HISTORIC AND DESIGN REVIEW COMMISSION

HDRC CASE NO: 2017-630
ADDRESS: 429 DEVINE ST
LEGAL DESCRIPTION: NCB 2957 BLK 1 LOT 8
ZONING: R-5, HS
CITY COUNCIL DIST.: 1
DISTRICT: Lavaca Historic District
LANDMARK: House
APPLICANT: Richard & Susan Theis
OWNER: Richard & Susan Theis
TYPE OF WORK: Construction of a single family residential structure
APPLICATION RECEIVED: March 26, 2018
60-DAY REVIEW:
REQUEST:

**Historic and Design Review Commission
Design Review Committee
Report & Recommendation**

English Vendrell Architects T 773.450.3266 Emkengkenglish@gmail.com
			PROJECT # SA01
			REVISED: February 12, 2018
			PROPOSED THEIS FAMILY RESIDENCE
			SUSAN & RICHARD THEIS WITH FAMILY
			429 DEVINE ST. SAN ANTONIO, TX.
			DATE: February 2, 2018
			DRAWING TITLE SITE EXISTING TREES
			SHEET 3B

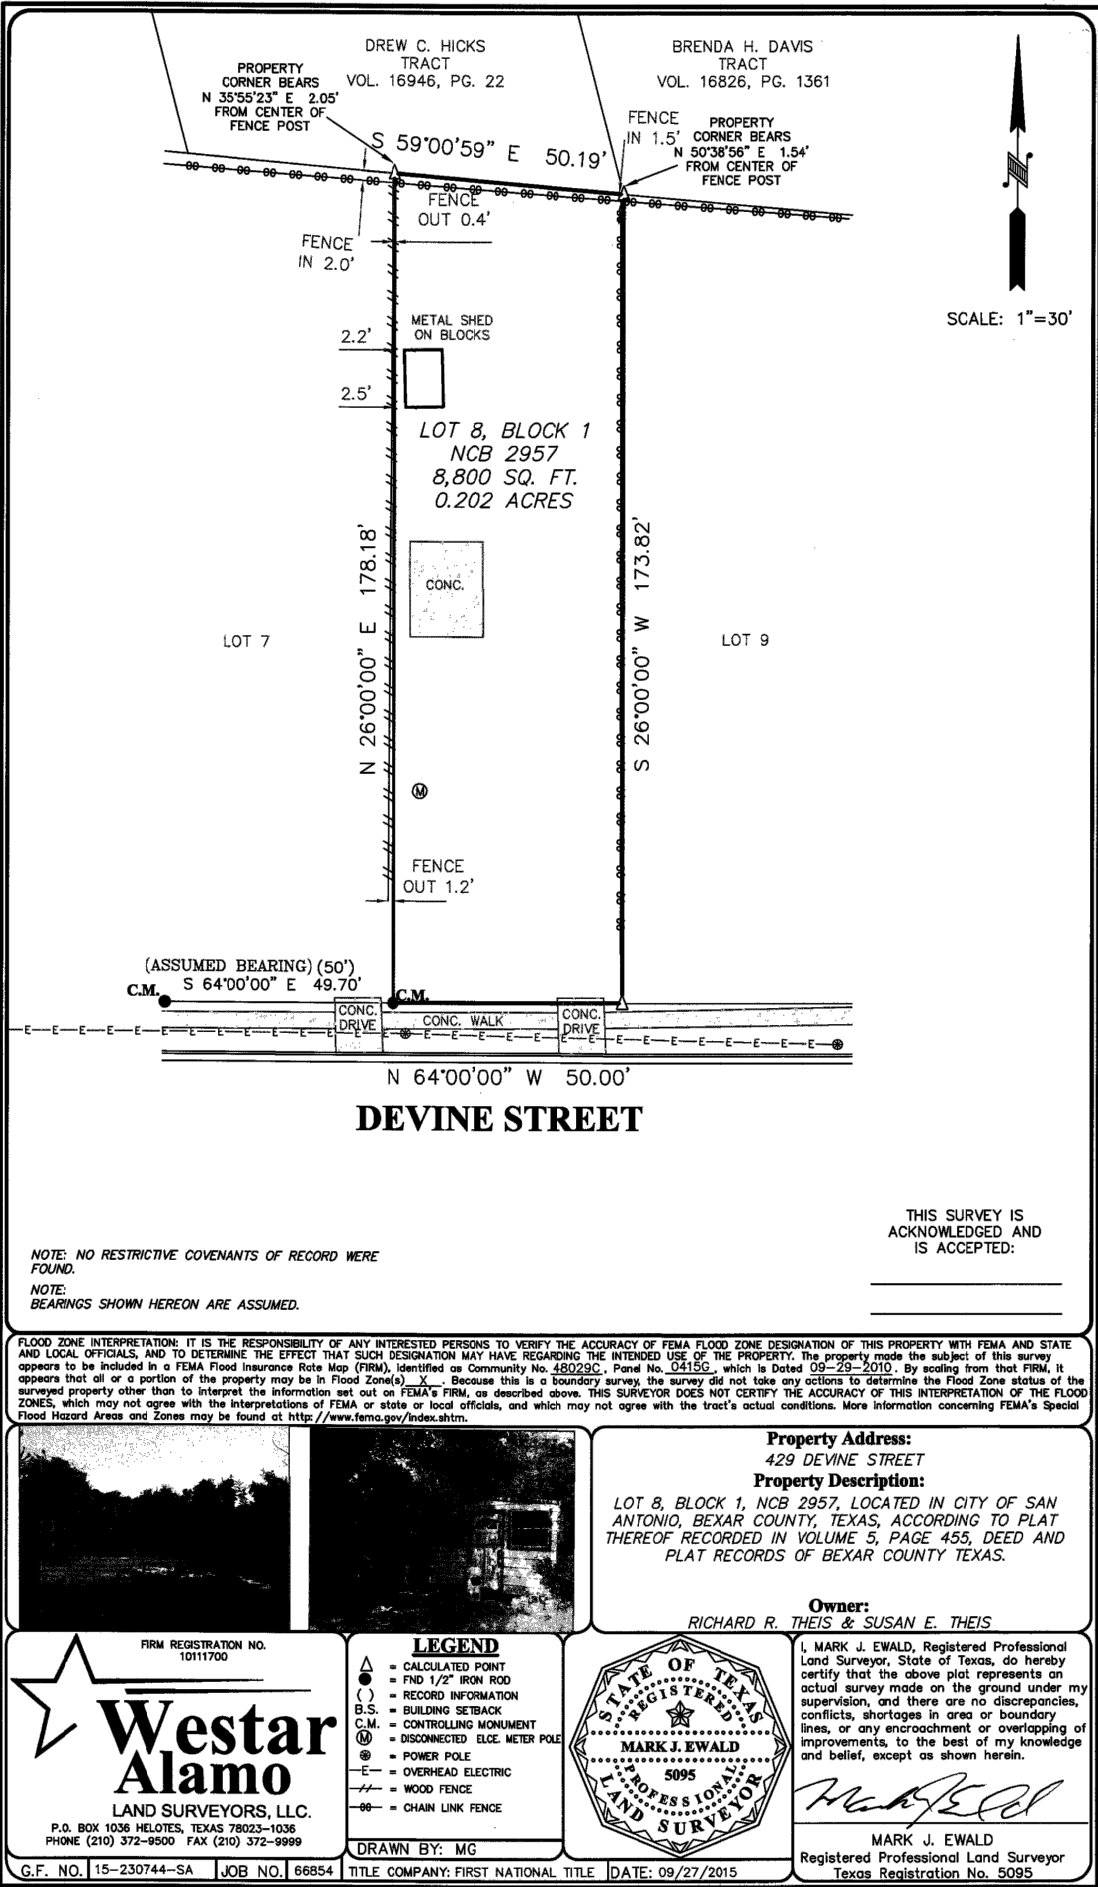
COMMENTS/CONCERNS: ME: OVERVIEW OF UPDATES TO DESIGN -
SETBACKS, PORCH MASSING - DEPTH 2". JL: QUESTIONS REGARDING
ROOF PROFILE - PORCH ROOF WILL FEATURE SLIGHT SHEA PITCH.
JL: QUESTIONS REGARDING WALLS BEHIND PORCH. - ME: COURTYARD
WALL. JL: QUESTIONS REGARDING PARKING - FRONT YARD DRIVEWAY.
JL: QUESTIONS REGARDING PROPOSED CONCRETE PAVERS. JL: QUESTIONS
REGARDING THE RATIO OF PERMEABLE IMPERVIOUS TO PERVIOUS PAVING.
JL: QUESTIONS REGARDING THE RETENTION OF EXISTING TREES

These are the trees as they exist on the site. We do not intend to keep any of the trees. Please see the site plan for information on new trees that will be planted.

DRAWING TITLE
FLOOR PLAN
SHEET 1

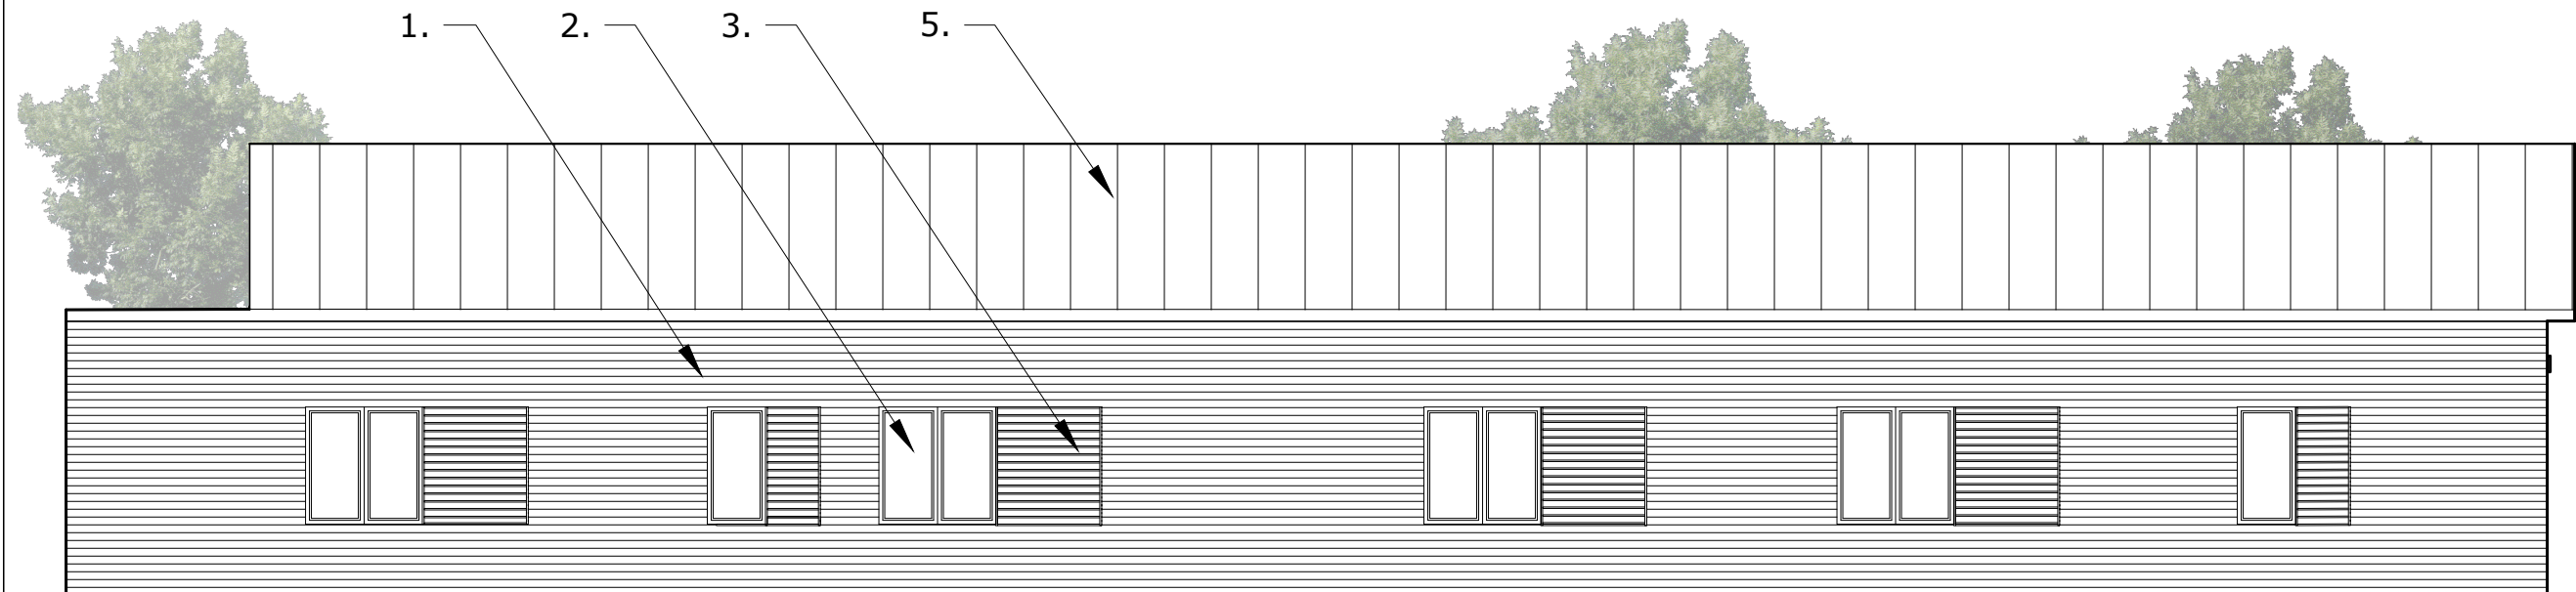
- iii. That the proposed side gable that starts to the rear of the courtyard be shifted forward to the rear of the front porch. **The applicant has noted the installation of a gabled roof at the front of the house so that the forward most courtyard is obscured and a more tradition porch massing is used.**

- vi. That the proposed front yard driveway/parking location extend along the side of the proposed new construction rather than stop in the front yard. **The applicant has provided documents that meet this stipulation.**

- vii. That a ribbon driveway and a solid, continuous walkway be installed. **The applicant has provided documents that meet this stipulation.**
- d. SETBACKS & ORIENTATION – According to the Guidelines for New Construction, the front facades of new buildings are to align with front facades of adjacent buildings where a consistent setback has been established along the street frontage. Additionally, the orientation of new construction should be consistent with the historic examples found on the block. Per application documents, the applicant has noted a setback greater than those found historically on the block. This is consistent with the Guidelines.

2 WEST ELEVATION
SCALE 1/8" = 1'-0"

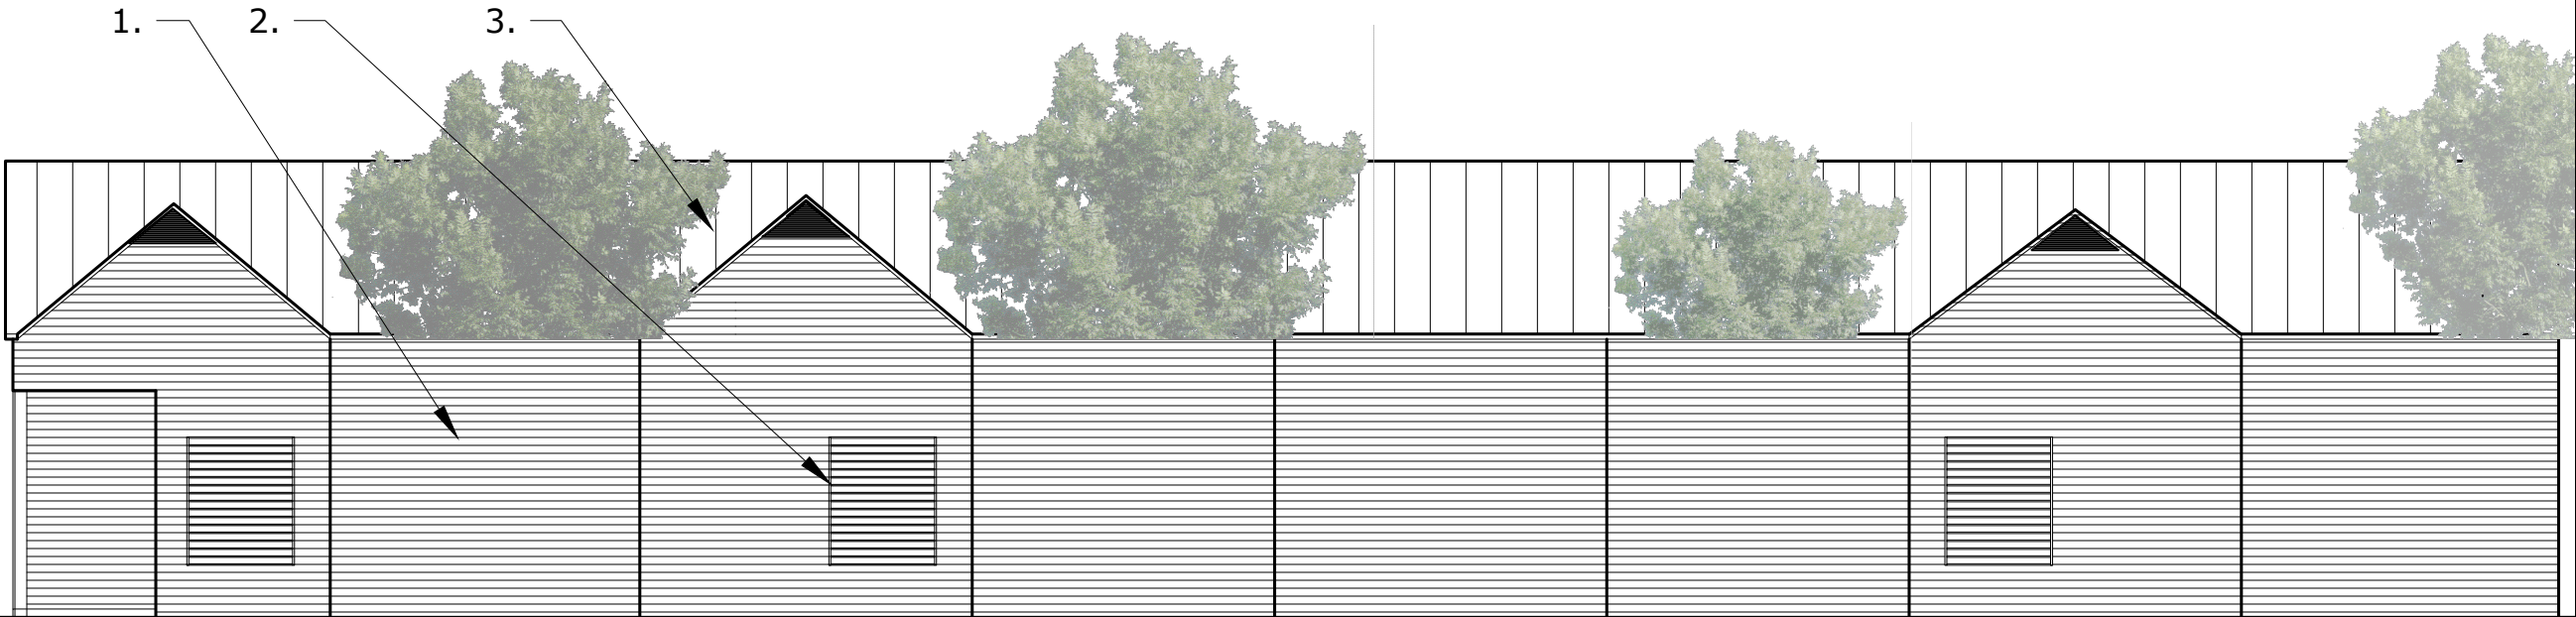
JG: QUESTIONS REGARDING THE WEST ELEVATION. ME- OPENINGS FEATURE SLIDING OPERABLE ELEMENTS.

JG: QUESTIONS REGARDING OPERABILITY OF WINDOWS.

JG: CONCERNS REGARDING LACK OF WINDOW FENESTRATION - PROFILE OF WINDOWS SHOULD BE PRESENT.
